Officer Report

HGY/2026/0298

Non-Material Amendment

Bernard Works, Bernard Road, Tottenham, London, N15 4NX

Figure 1: Site Plan indicating relevant blocks

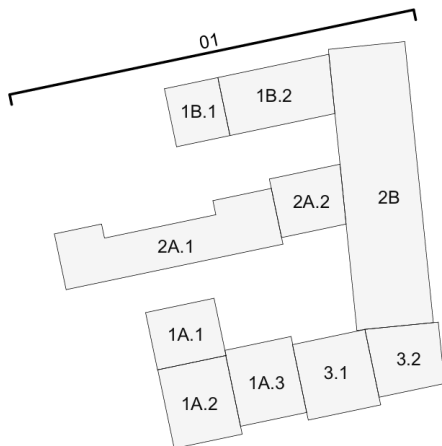
- Removal of 6th floor of accommodation in Block 1A. The top floor will retain a similar appearance but contain plant only;
- Reduction in commercial floorspace from 2,446.9sqm to 2,405.2sqm and amendment to description of development to reference this amendment and omit reference to 25no. commercial units;
- A reconfiguration of the housing mix to increase quantum of studio units and reduce quantum of 2 bed units;
- Design changes (including extension of deck access and addition of recessed balconies within Block 1B, changes to doors and windows, stairwells, cladding material and coping detail); and
- Layout changes from rationalisation of approved two entrance cores within Block 2B to create a single entrance, removal of individual entrance doors; reconfigured bike and refuse stores.
- See Figure 1 below for the site plan indicating the relevant blocks and site layout.
